RE: BAT Site Plan comments; Henryton Heights, Lot 14 (Punte residence)

The following amendments, deletions, or revisions are needed on the submitted BAT Plan for the subject property.

PROJECT: **1675-A HENRYTON ROAD HENRYTON HEIGHTS SECTION 2, LOT 14 PLAT 3502**

TITLE: **SITE PLAN FOR BAT INSTALLATION**

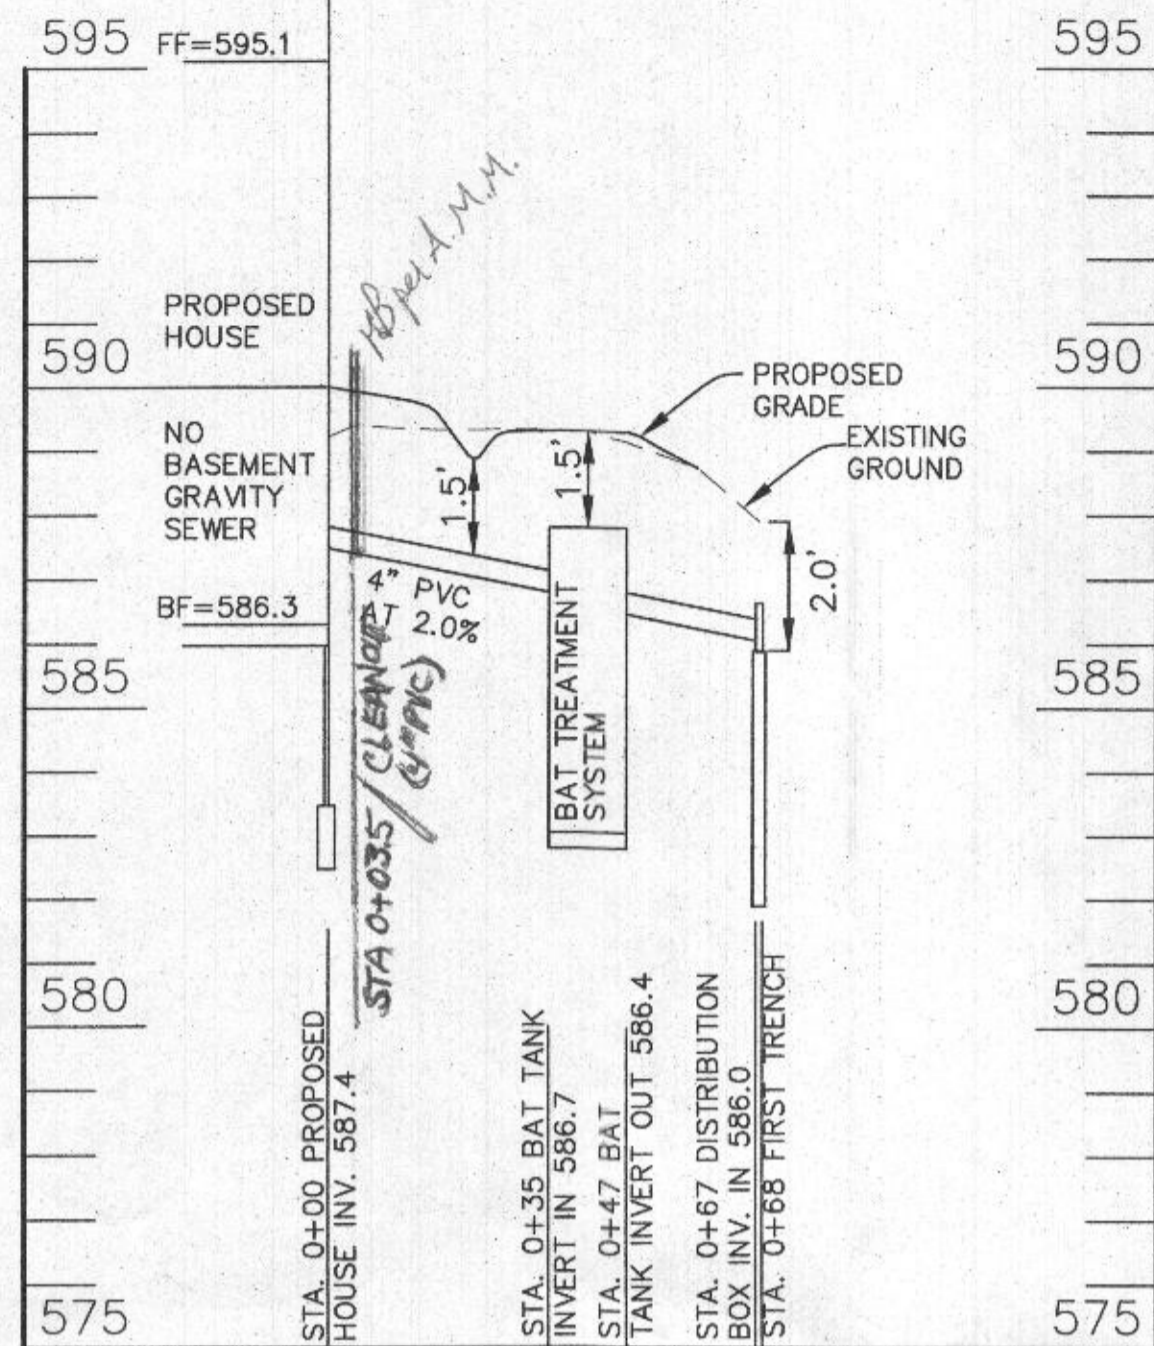
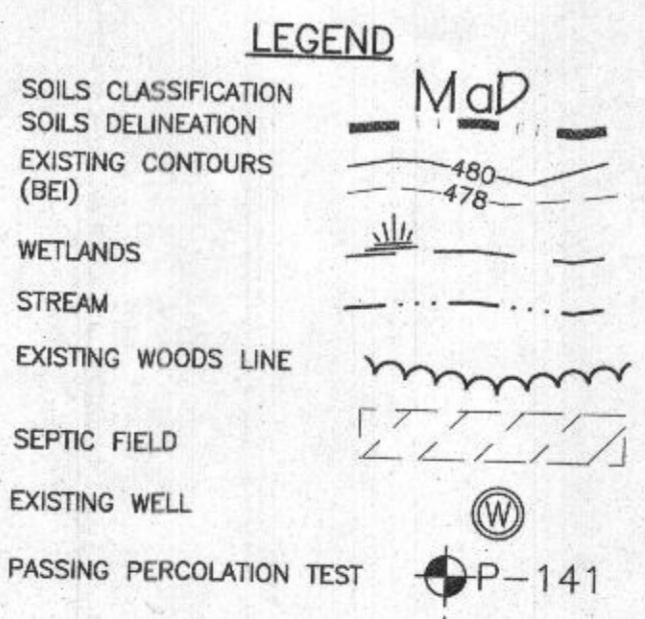
1. Prominently place a label on the plan which states that Public Water will be used.
2. Illustrate and label the Water House Connection (WHC). Observe all setbacks and construction requirements, e.g. sleeve the water line as it crosses under the driveway, and continue the sleeve for about 5 feet beyond the crossing.

3. 'DW-1' is within 100 feet of a well on the neighboring property. Move the location of 'DW-1'.
4. Illustrate the label "100.0' SEPTIC OFFSET" and the line that delineates the offset across the sewage disposal area (SDA) with greater amount of points.

5. As the upper corner of the SDA is not being used for trenches, illustrate the BAT tank in the upper corner of the SDA. While maintaining appropriate depth for the Sewer House Connection (SHC), plan a more direct path from the house to the SDA.

6. The distribution box may be at the edge of the SDA, not necessarily within the boundary.
You are proposing the effective area (and trench pipe invert) to be at 1.8'. Typically, the depth selected for the distribution pipe is at one of the 0.5-foot increments between 2 feet and 4 feet.

- a. Recalculate the coefficient and the subsequent trench length
 - b. Accurately illustrate the trench length.
 - c. Label each trench with the proposed distribution pipe invert elevation.

- d. Illustrate the correct spacing between trenches. (You calculated 11.4 feet for spacing, but illustrated only 10 feet.) The measurement is wall-to-wall.

8. You are giving me trench data for a 4-bedroom residence, but proposing a BAT unit for a 5-bedroom residence. A correction is needed.
9. The 'TYPICAL TRENCH DETAIL' isn't making sense.

10. Propose a location for the Control Panel where access will not be hindered by a deck or other structure.
